DATE: 04.23.2019
TO: ProTrak
FROM: Mitesh Baxi
Traffic Engineering

■ **AUTO WASH & OIL CHANGE FACILITY [TRC Plan Review]**

↻ Initial Review Note ↻

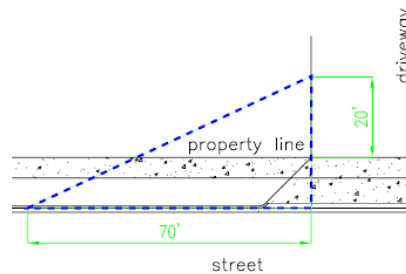
1. This segment of Dawson St is a major thoroughfare [Chap VII (C) (2) of CofW Tech Stds]. Driveways for lots along major thoroughfares must be at least 75' offset from property lines measured at the curb line. [Chap VII (C) (2) (c) (2) of CofW Tech Stds]. A variance may be required for Dawson St driveway.
